Comments on 2011 Administrative Civil Liability Order R5-2011-XXXX for the City of Colfax

Comments on the draft Cease and Desist order NO. R5-2011-xxxx for the City of Colfax Wastewater Treatment Plant. (Submitted by Allen Edwards)

Figure 1. Dam Slope Measurements (approximate, not to scale)

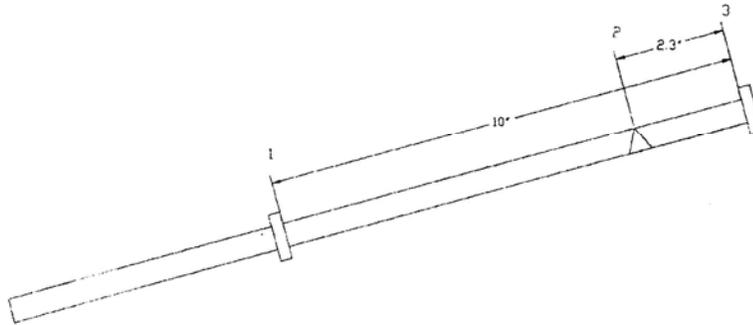
We have determined that the dam slope measurements used to calculate pond elevations were incorrect from March 16, 2011 to March 21, 2011.

Pond 3 elevations and volumes are determined from tabularized relationships based on the height of water on the pond's dam. The physical measurement taken by Operations staff occurs on a sloped pipe (Figure 1), with markers at 10 foot intervals. Before March 16, 2011, there was more than 10 feet of dam slope, and measurements were based on the 10 foot mark on the slope (see **point 1** in Figure 1). Between March 16, 2011 and March 22, 2011 the dam slope measurements were incorrectly based on an out of date mark on the slope (see **point 2** in Figure 1). As the pond levels increased, it became apparent that the mark being used was incorrect. On March 22, 2011 the correct mark on the slope was identified (**point 3** in Figure 1) and used thereafter for dam slope measurements. The distance between the two marks is 28 inches. The incorrectly reported values are detailed in Table 1. The corrected values are detailed in Table 2.
